**CONSOLIDATION UN-R138
WITHOUT REGULATORY VALUE**

Addendum 137 – Regulation No. 138

Uniform provisions concerning the approval of Quiet Road Transport Vehicles with regard to their reduced audibility (QRTV)

Figures 2a and 2b
Measuring positions for vehicles in motion indoor and in standstill
[additional 2 microphones needed at the front and in the back]

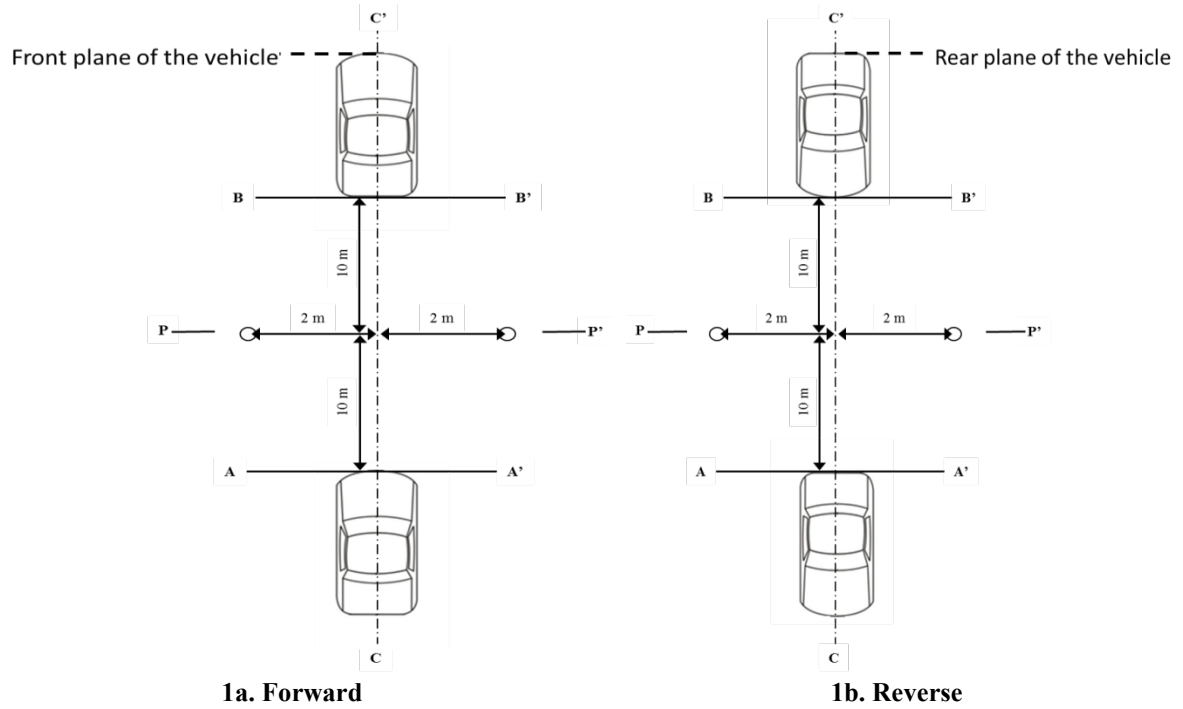
For the measurements of the opposite side of driving direction at method “B”, “C”, “D” additional microphones are necessary (see figure 2a , 2b).

Figure 5

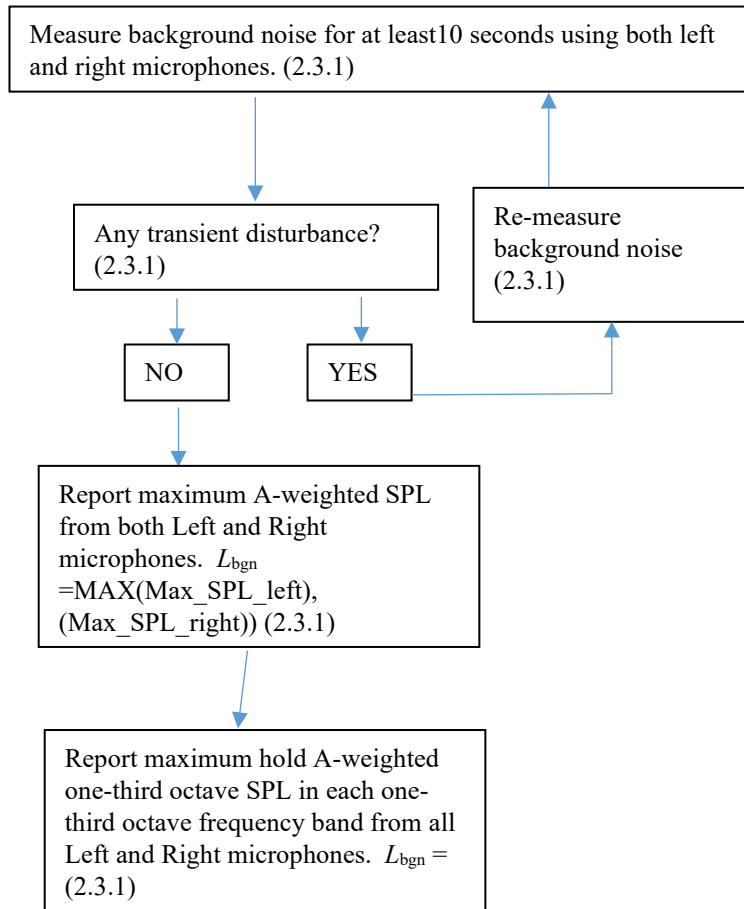
As an aid for background noise requirements when analyzing in one-third-octave bands see flowchart in Figure 6-5 (needs update) of the Appendix to this annex.
